Technical Service Bulletin

SUBJECT:		No: TSB-22-42A-001	
DRIVER'S SIDE WINDOW SWITCH INOPERATIVE		DATE: March 2022	
		MODEL: See Below	
CIRCULATE TO:	<input type="checkbox"/> GENERAL MANAGER	<input checked="" type="checkbox"/> PARTS MANAGER	<input checked="" type="checkbox"/> TECHNICIAN
<input checked="" type="checkbox"/> SERVICE ADVISOR	<input checked="" type="checkbox"/> SERVICE MANAGER	<input type="checkbox"/> WARRANTY PROCESSOR	<input checked="" type="checkbox"/> SALES MANAGER

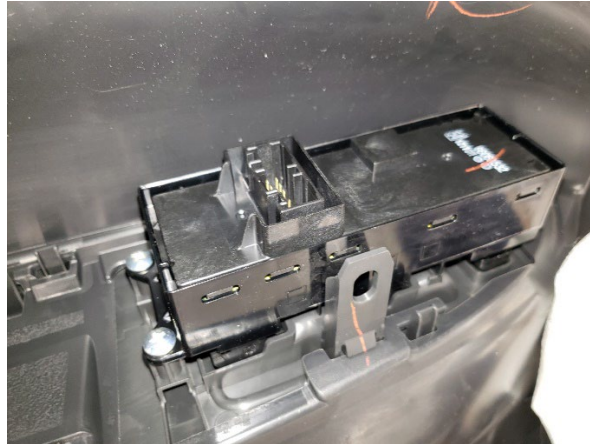
5. When removing the door panel, use extra caution with the top left clip (see image below) as it will easily break.

6. Gently pull the front door trim assembly to the inside of the vehicle to remove it and disconnect wire connectors.
